Independent Rapid Assessment of the Parramatta CBD Planning Proposal for DPE

1st March 2022

Bennett and Trimble

River Foreshore

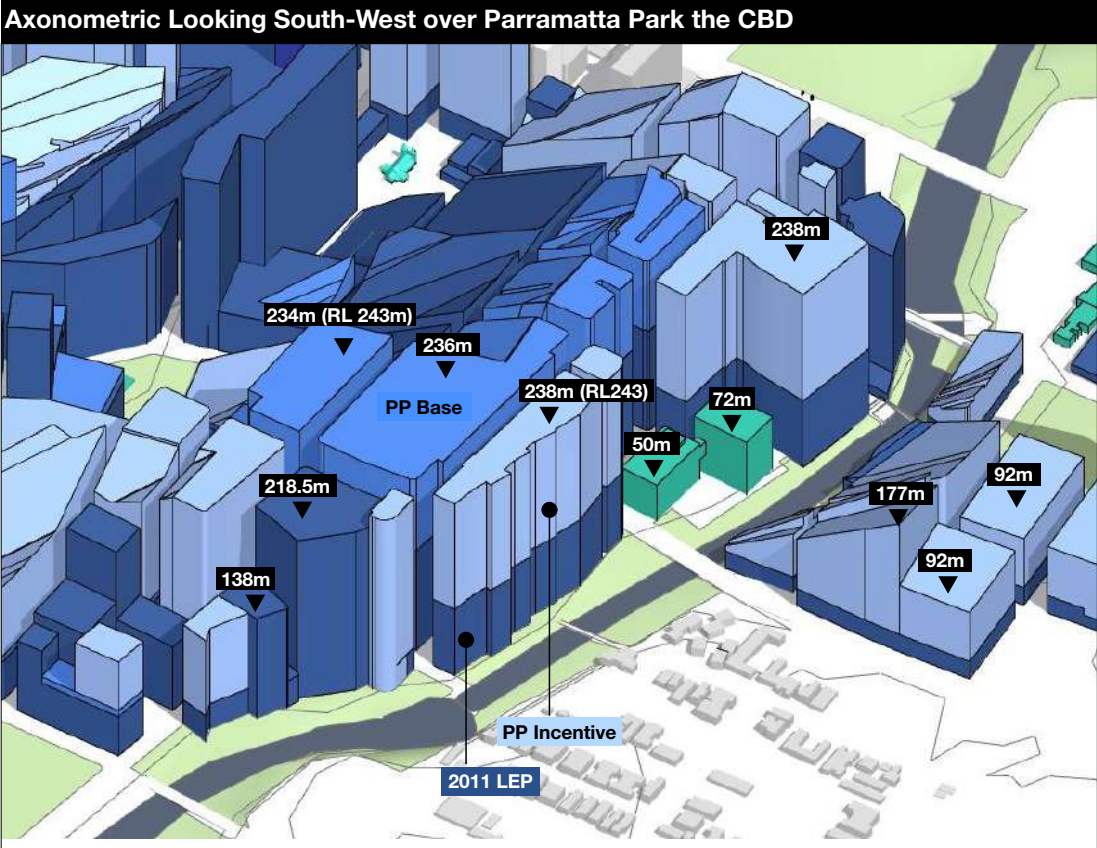
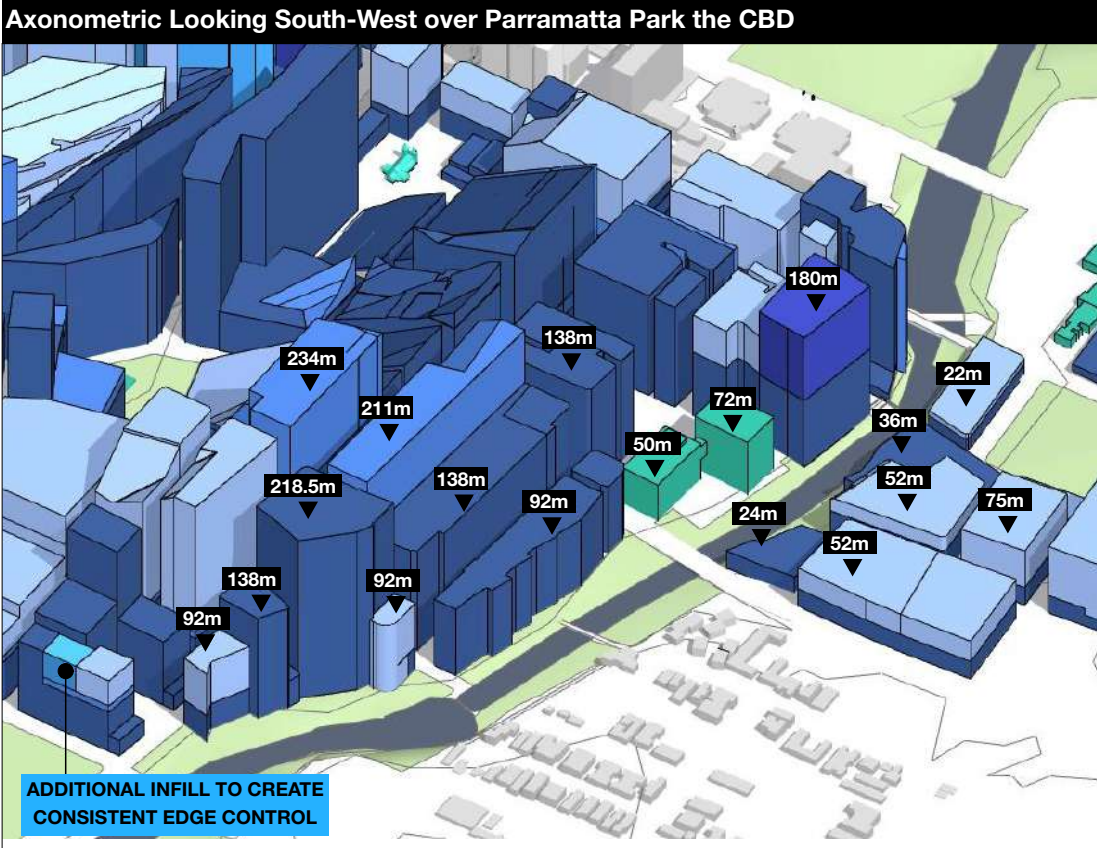
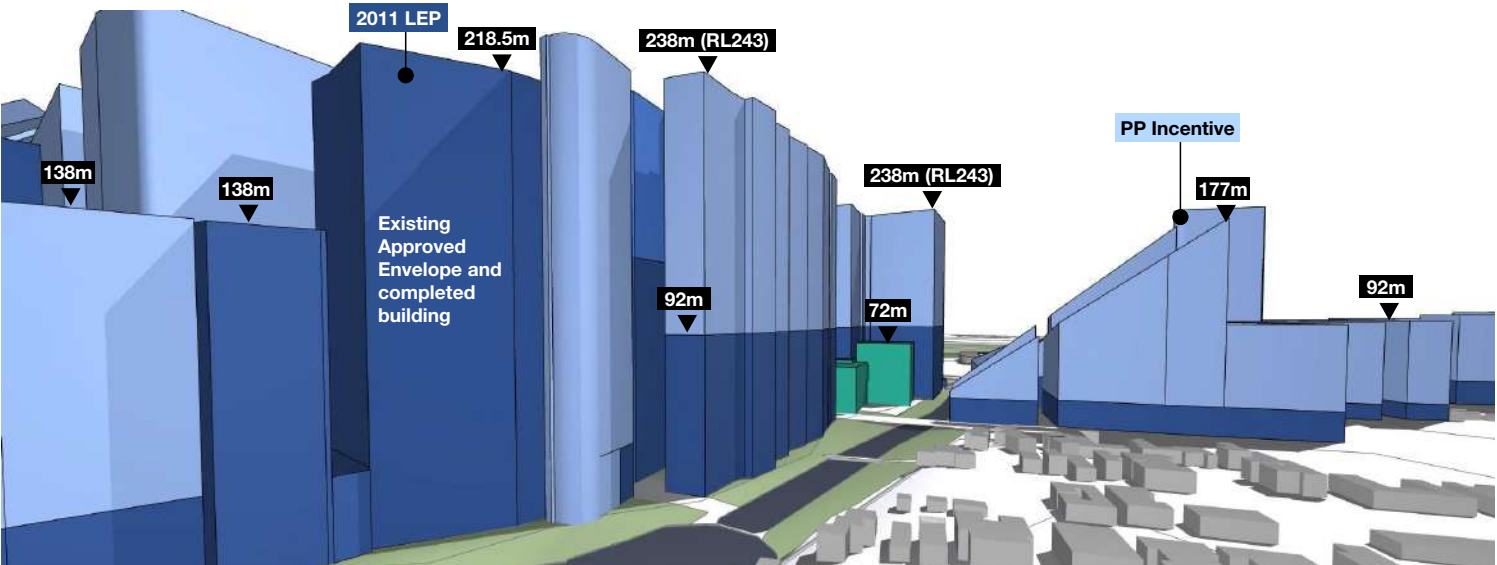
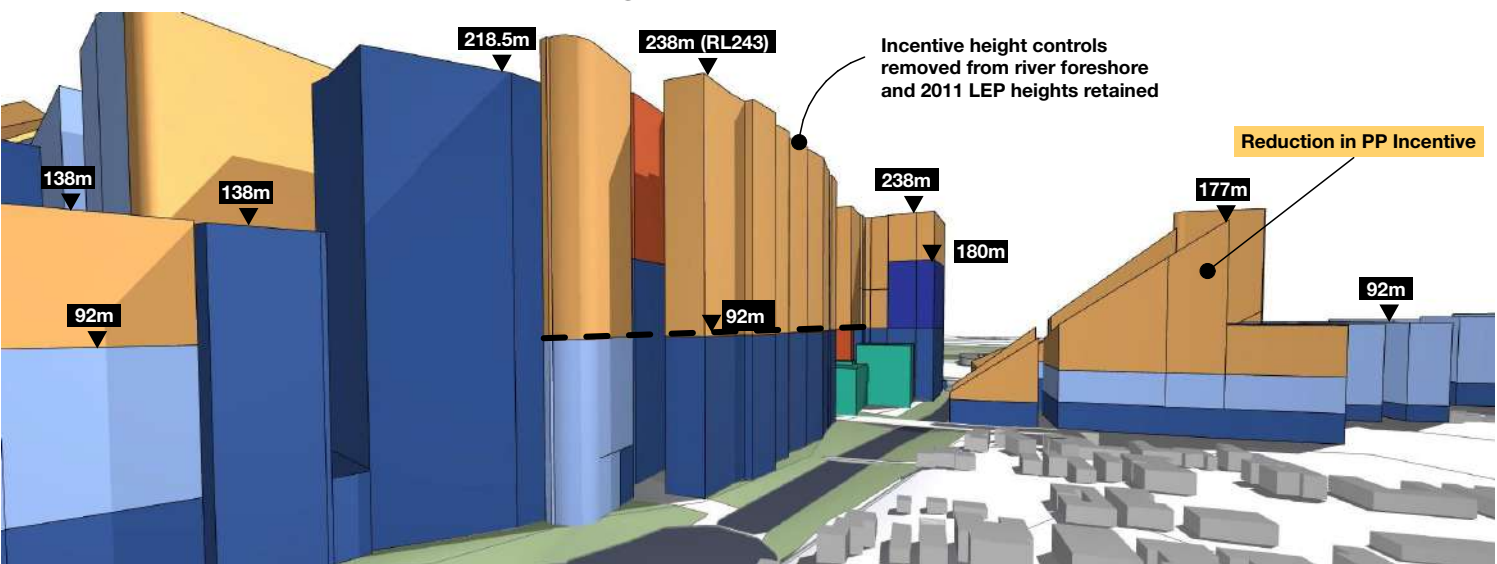
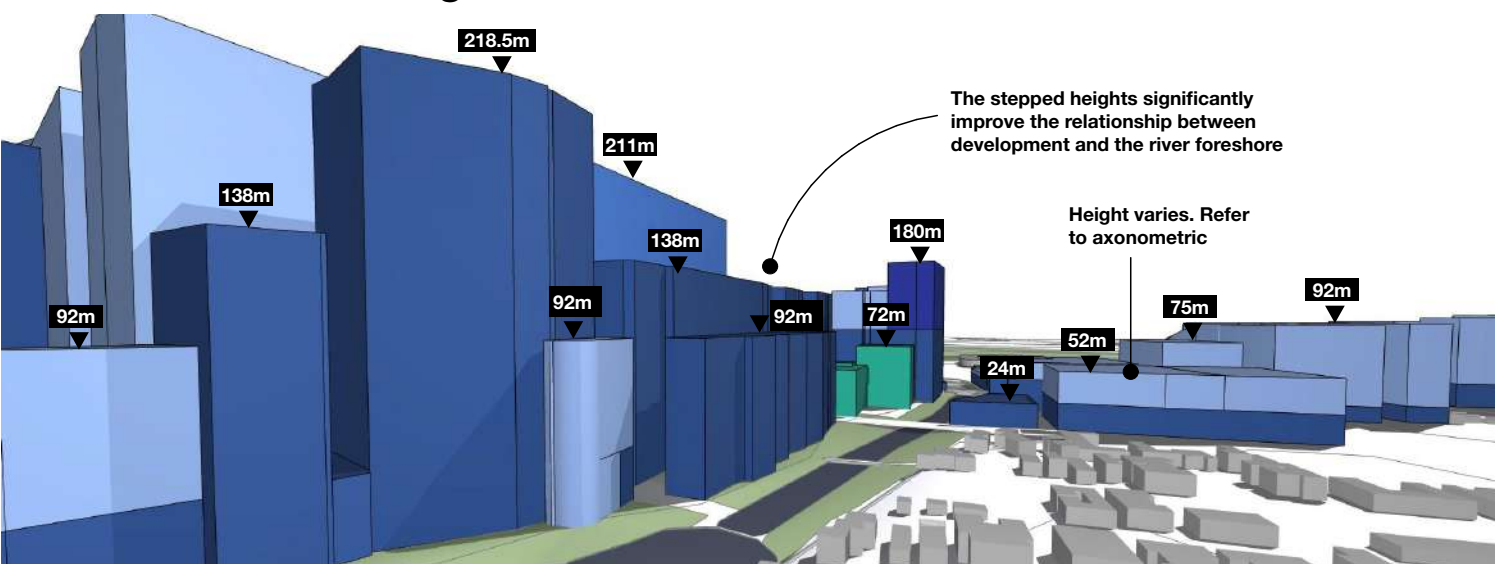
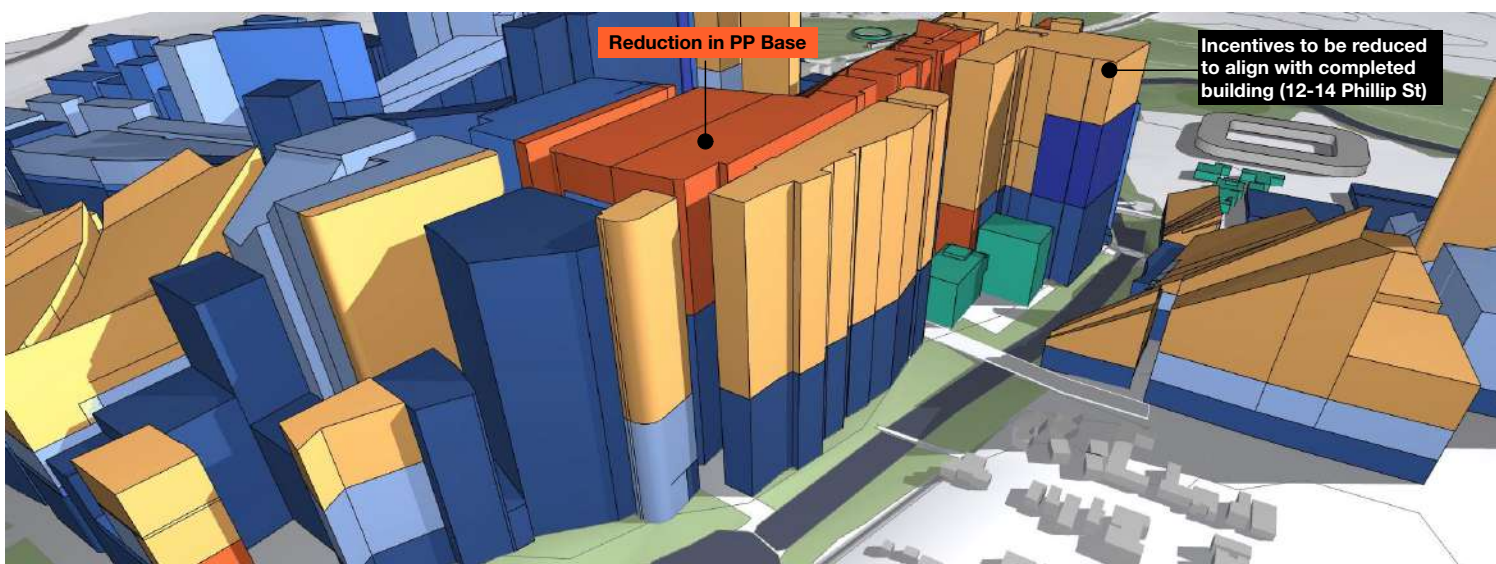
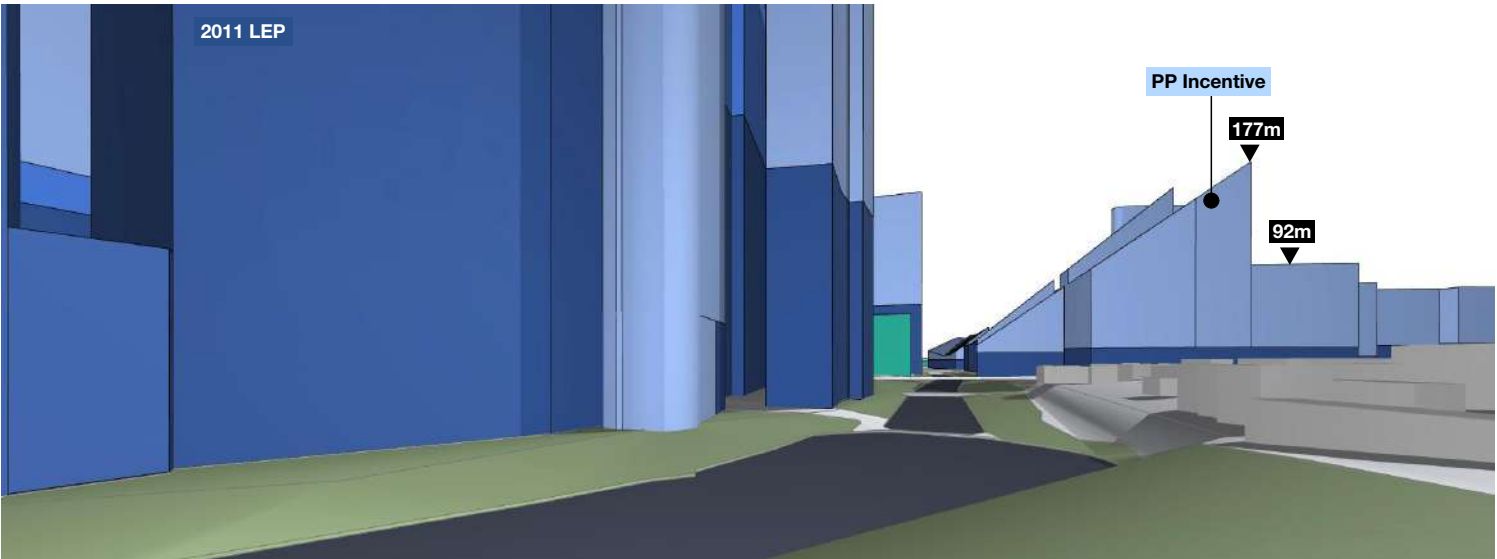
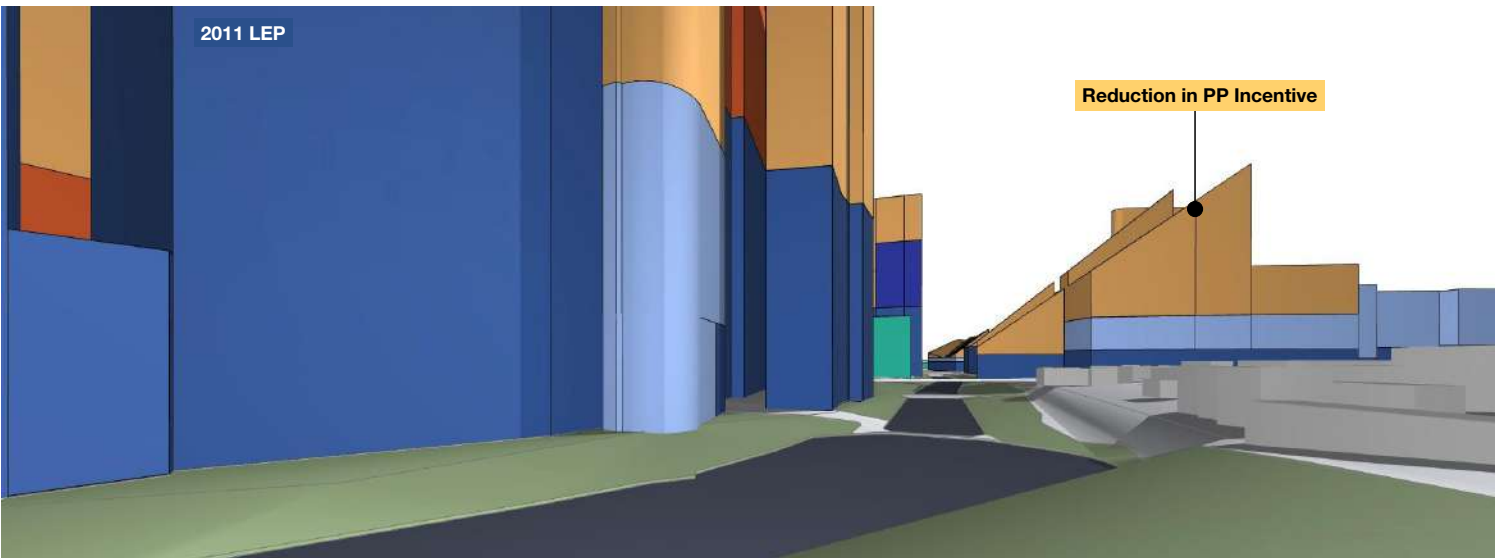
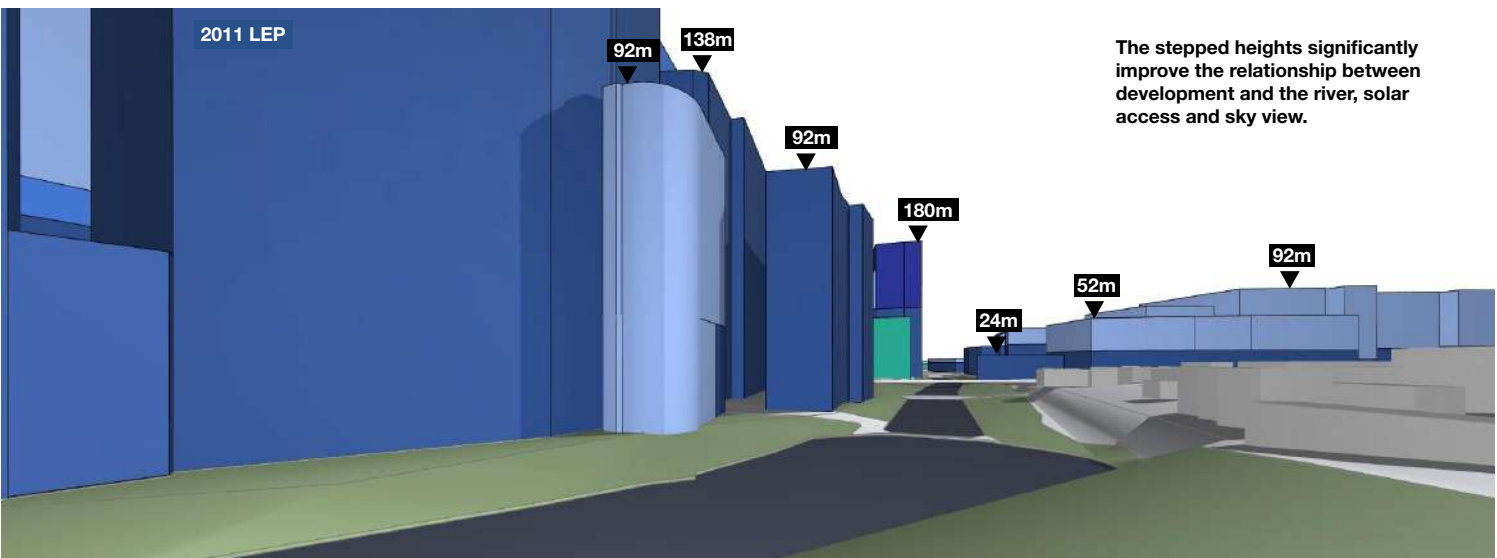
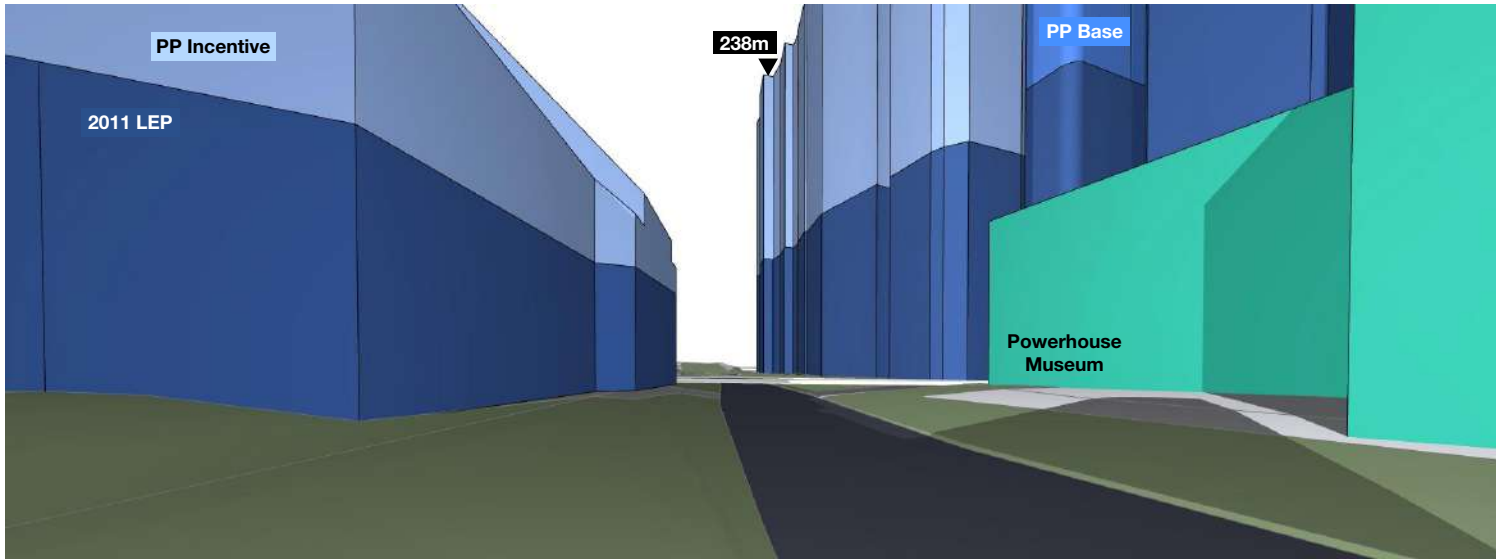
Parramatta has a unique relationship with its river and the current Planning Proposal risks jeopardising this relationship for future generations.

The relationships between the recently completed tall buildings and the river is unconvincing. They appear to commercialise the foreshore and visually dominate the river corridor. This type of development is similar to Southbank in Melbourne or Barangaroo in Sydney, and may not offer the most sensitive or place-specific response that Parramatta deserves.

Any additional height or FSR (including incentives) allowed as part of this Planning Proposal should be removed to the sites along the southern foreshore.

The height plane controls to the north of the river should be reconsidered and consolidated to establish more consistent building heights that step down to the river to mitigate bulk, and maintain or improve solar access and sky views from the foreshore and Civic Link.
